MULLION MATE 3
SECTION DETAIL

SUBMITTAL IDENTIFICATION SHEET

WEBSTER UNIVERSITY ISB
PROJECT NAME

Extruded aluminum trim product data and schedule.
mullion mate
gordon 911
gordon 911-EC 200
gordon 234
gordon 314 - 5/8

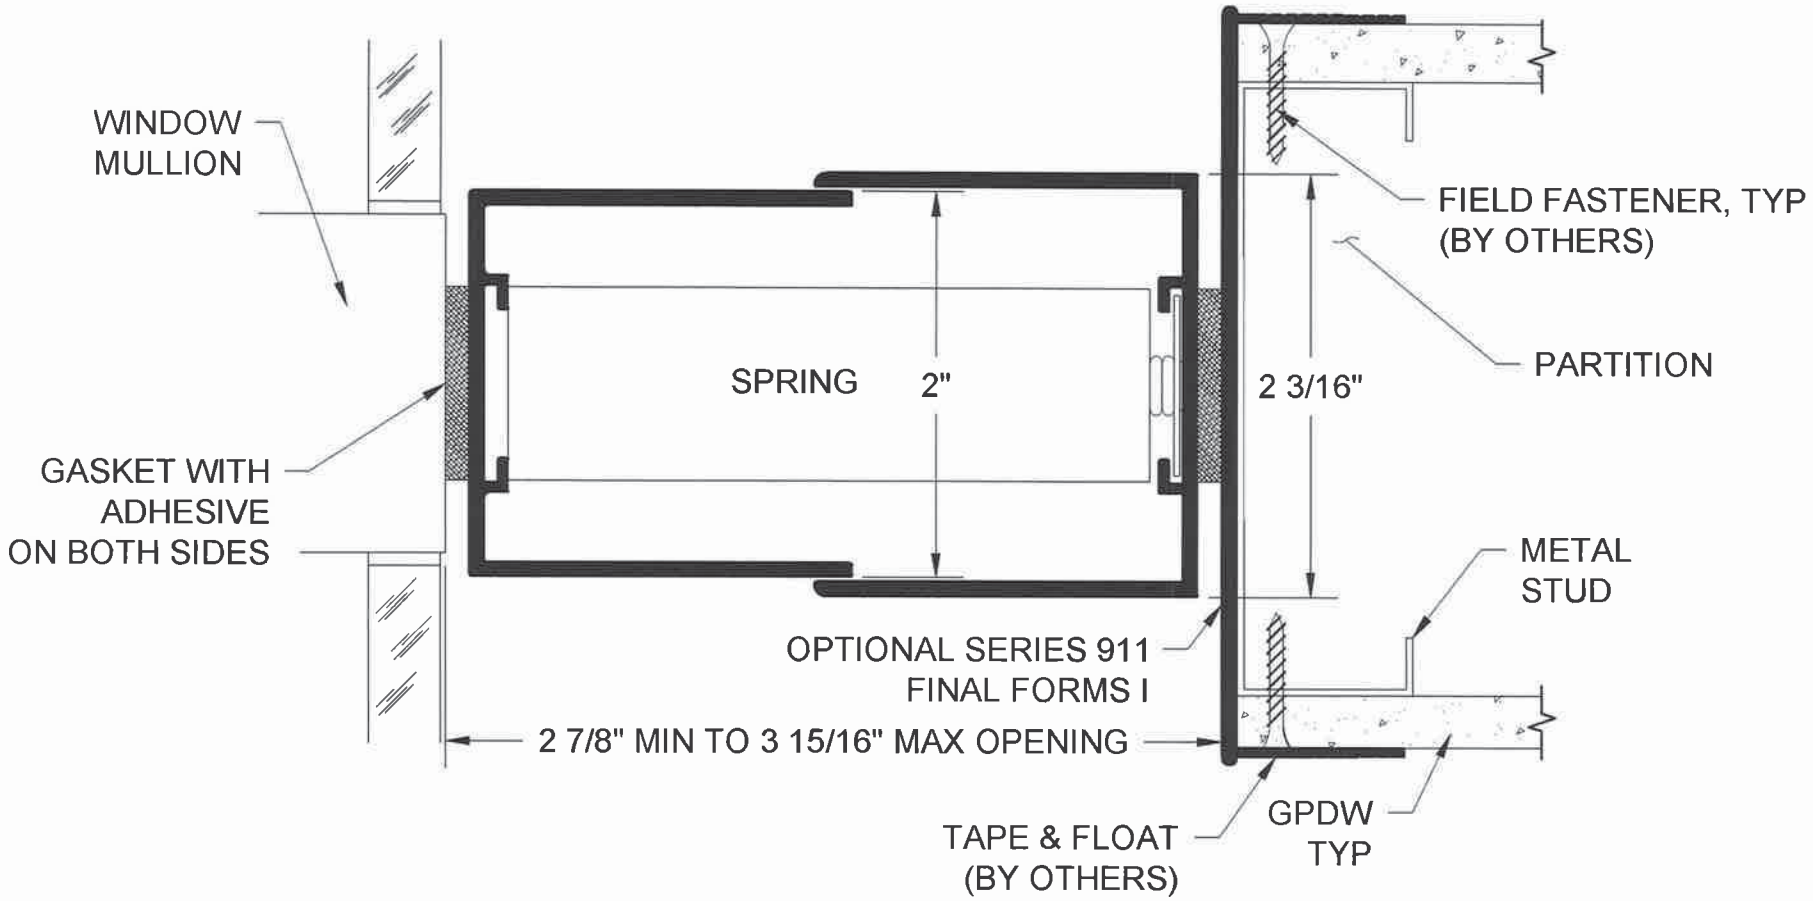
For the Mullion Mate and for the other extruded trims on the project, we would like one of the four available standard whites – please provide samples of all white colors from Gordon for selection. See markups.

Design intent is to select the one that most closely matches Sherwin Williams SW 7004 Snowbound.
